Flamingo Fashions Limited, Unit-2 (Extension)

Mariali, Joydebpur, Gazipur.

16 January 2023 & 26 February 2023

Observations

Retrofitting design requires detail review

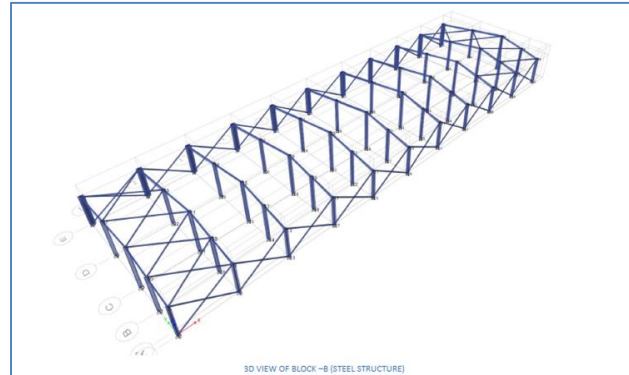
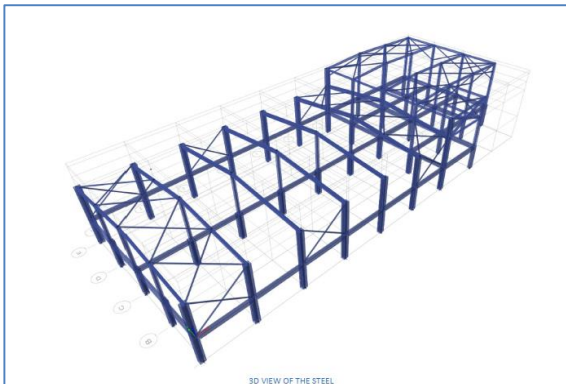
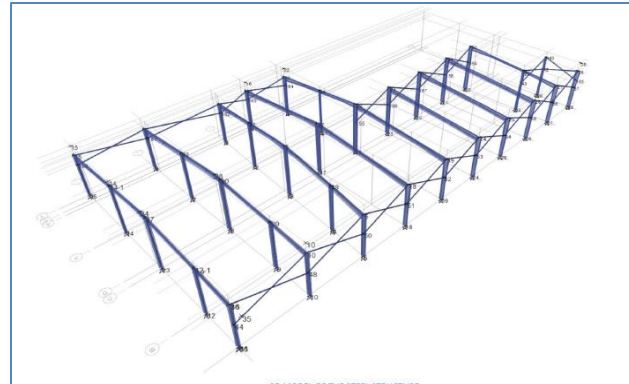
Moreover, in the provided design report material specification, details calculation of wind and other input values are not mentioned. In FEA model yield strength of rafter has been considered 50 ksi. Before submitting the EA the building engineer is required to incorporate the all the issues in revised EA.

The factory conducted retrofitting with some irregular sections which are modeled with equivalent sections in the analysis software. During inspection Engineering Assessment (EA) report was available onsite. The factory is required to submit the EA report to the RSC for detail review.

Vertical bracing missing

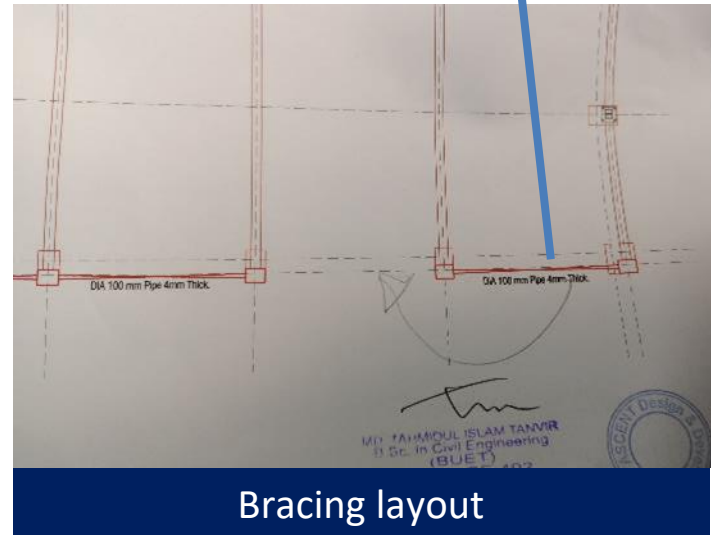
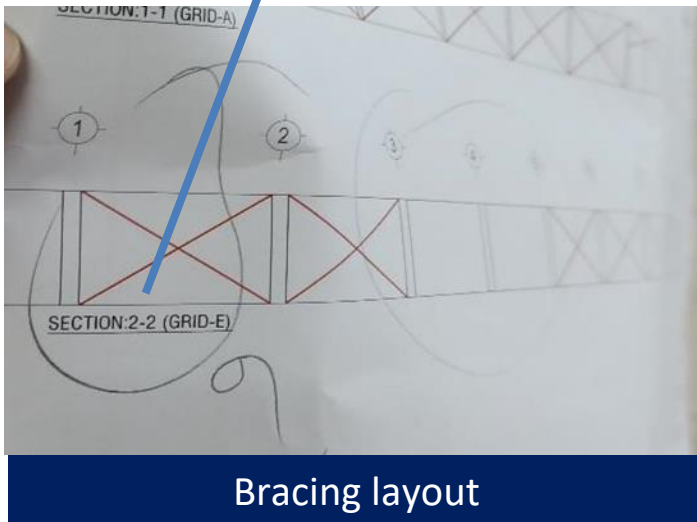
Bracing was found missing at corner grid of Lingerie Shed-part B & C as per the factory provided drawing. Building engineer is required to install the missing bracing as per the accepted drawings.

**Non-structural elements not
anchored or braced**

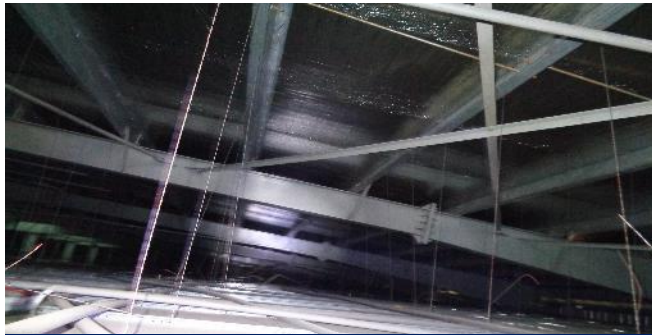
Racks without anchoring

Some racks on the floor are not adequately anchored or braced to resist lateral (earthquake) forces. Building engineer is required to adequately anchor and brace all non-structural elements to resist earthquake forces to comply with the BNBC.
